DFE Differences Between Annex 178A and Clause 180

Norman L. Swenson, Ph.D.
Norman Swenson Consulting
Affiliations: Nokia and Point2
10 March 2026

Figure 178A-9—Receiver discrete-time equalizer

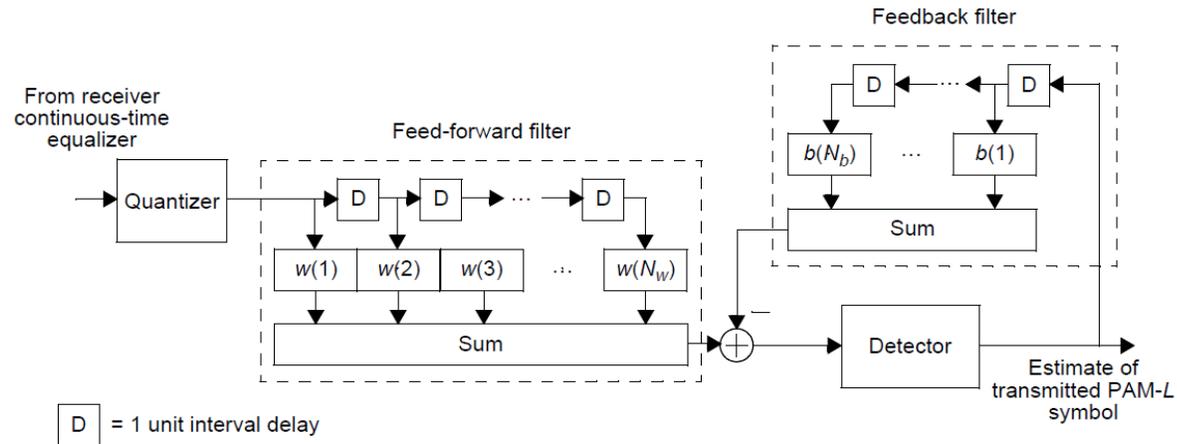
- As the caption says, this is a discrete-time equalizer; all of the circuits are clocked at the symbol rate, $1/T$
 - I would prefer “Sampler” over “Quantizer”; it samples the analog waveform at discrete T-spaced time intervals
- This is the DFE described in most literature and textbooks.
 - T-spaced DFEs are often preceded by a matched filter
 - Fractionally spaced DFEs (with sampling faster than $1/T$) are also common.
- ***There is no eye diagram.*** There is simply one sample per UI.
 - An eye diagram requires a continuous time waveform at the input to the Detector

Figure 180–10—TDECQ reference equalizer functional model

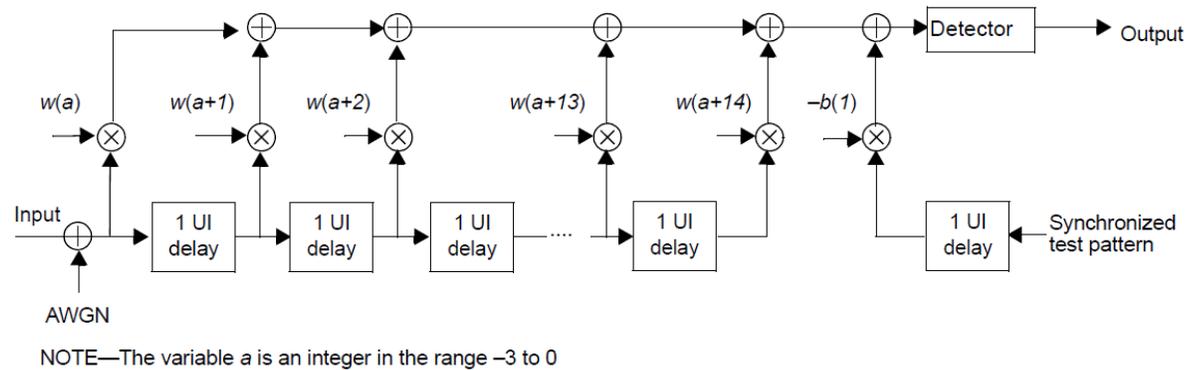
- From 180.9.6.3 Reference equalizer:
 - “The reference equalizer is a 15-tap, T-spaced, feed-forward equalizer (FFE), followed by a 1-tap decision feedback equalizer (DFE)”
- This is not a DFE (there is no decision feedback path)
 - This is a “functional model” of a DFE, assuming correct decisions are made by the Detector.
- There is no figure of a true DFE in Clause 180
- Though not explicit, the use of the DFE implies a *continuous time* equalizer, which differs from that given in Annex 178A

- Add a figure of the reference DFE shown on page 6
 - This can be a companion figure to Figure 180-10, the functional model shown on page 4
- Add text describing the DFE reference equalizer as a continuous-time equalizer
- Change the sample eye diagram in Figure 180-11 to show discontinuity resulting from feedback (see page 6)

The reference equalizer is a continuous-time decision feedback equalizer consisting of 15 symbol-spaced feed-forward taps, a decision circuit (Detector), and 1 feedback tap.

Figure 180-11—Illustration of the TDECQ measurement

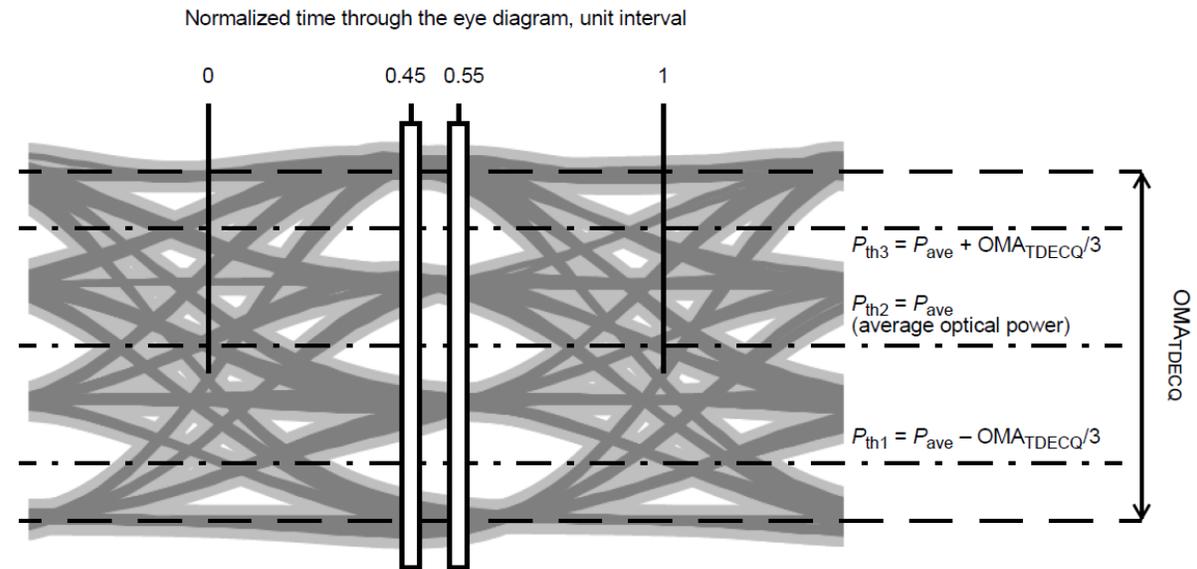
- The description of the TDECQ computation relies on a continuous-time receive eye diagram
 - Clause 180.9.6.4 speaks of zero crossings and “two vertical histograms [that] are measured through the eye diagram”
- The only way to have such an eye diagram is to remain in continuous time until the slicer
- The feedback filter must also be continuous time (unlike a classic DFE), but is **clocked**
 - It only changes value once every symbol period and holds that value until the next clocking

- Describing the reference equalizer as a “feedforward equalizer followed by a feedback equalizer” is not standard terminology
 - A DFE is normally described as a transversal feedforward filter , a decision element, and a transversal feedback filter – that is, the DFE includes the feedforward section
- The eye diagram of Figure 180-11 should show a discontinuity where the feedback level changes value.

TDECQ continuous-time reference equalizer

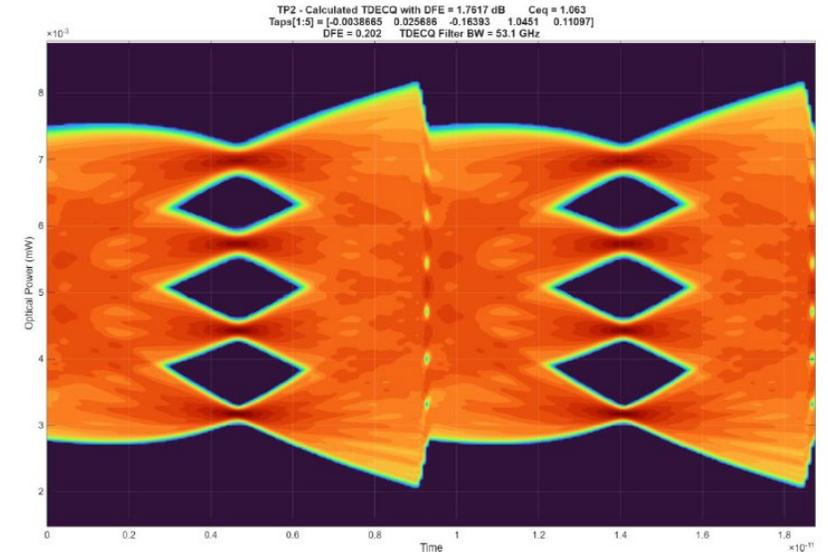
- The signal in this block diagram is **continuous time**.
- The eye diagram is measured at the input to the Detector
- The Detector is clocked and the output changes once per symbol period and holds its value for 1 UI.
 - An infinite bandwidth feedback path is implied
- **The delay d in the feedback path is not 1 UI** for the continuous-time feedback
 - If the delay were 1 UI, the feedback would be changing value exactly when you are making the next decision
 - $d \approx \frac{1}{2}$ UI. The exact value is not critical, as long as $.14 \text{ UI} < d < .86 \text{ UI}$ to ensure that the feedback changes value before the left vertical histogram slice or after the right vertical histogram slice
 - This representation is consistent with the TDECQ description but does not imply an implementation
